Access Compliance Report Public Rights-of-Way (Curb Ramps)

Main Street: CHIQUITA_CANYON_DR		Cross Street: LOS_PATRONES_PKWY		Location:	N
ADA ID: RPRK211130120705	Ramp Type: Type 1 - Perpendicular	Initial Pass/Fail: Fail	Overall Compliance: No	Severity Score:	15
Codes/Mitigation Info/Possible Solution			Field Measurements/Component Compliance

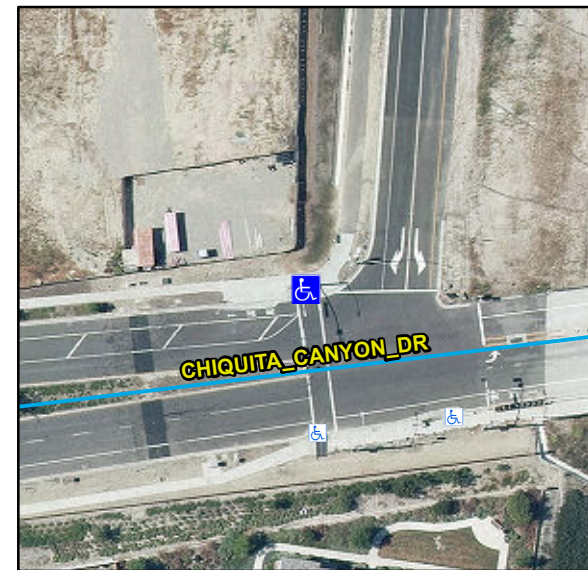
Compliance	Description	Data	Compliance	Description	Data
N/A	Ramp Length (in)	94	N/A	Flare Type LT	
Yes	Ramp Width (in)	48			N/A
No	Ramp Run Slope (%)	8.9	N/A	Flare Slope LT (%)	N/A
Yes	Ramp Cross Slope (%)	0.5	N/A	Flare Traversable LT	N/A
N/A	Landing Present	N/A	N/A	Flare Type RT	
N/A	Landing Length (in)	N/A			N/A
N/A	Landing Width (in)	N/A	N/A	Flare Slope RT (%)	N/A
N/A	Landing Run Slope (%)	N/A	N/A	Flare Traversable RT	N/A
N/A	Landing Cross Slope (%)	N/A	N/A	DWS Provided	N/A
N/A	Landing Movement Obstructed?	N/A	N/A	DWS Contrast	N/A
	Landing Movement Type	N/A	N/A	DWS Length (in)	N/A
N/A	Landing Shared	N/A	N/A	DWS Full Width	N/A
N/A	Clear Space	N/A	N/A	DWS Offset Left (in)	N/A
N/A	Clear Space To Crosswalk (in)	N/A	N/A	DWS Offset Right (in)	N/A
N/A	Marked Crosswalk 1	Yes	N/A	Marked Crosswalk 2	N/A
	Crossing 1 Direction	S		Crossing 2 Direction	N/A
	Marked Crosswalk 1 Width (in)	144		Marked Crosswalk 2 Width (in)	N/A

N/A	Ramp Inside Crosswalk 1	No	Yes	Ramp Inside Crosswalk 2	N/A
	Crossing 1 Slope (%)	3.4		Crossing 2 Slope (%)	N/A
	Crossing 1 Cross Slope (%)	0.8		Crossing 2 Cross Slope (%)	N/A
N/A	Gutter Ponding	N/A	No	Curb Slope	9
Yes	Gutter Lip Height (in)	0		Road Run Slope (%)	N/A
N/A	Gutter Run Slope (%)	N/A		Road Cross Slope (%)	N/A
N/A	Gutter Cross Slope (%)	N/A			
Yes	Overall Surface Condition: Acceptable		Yes	Perp Joint Present	Yes
	Cross Gutter Present?	No		Spandrel Present?	No
	Replace Cross Gutter?	N/A		Replace Spandrel?	N/A

Remove & Replace Entire Ramp. Restripe Crosswalk.

R304.2.2, STD 1115
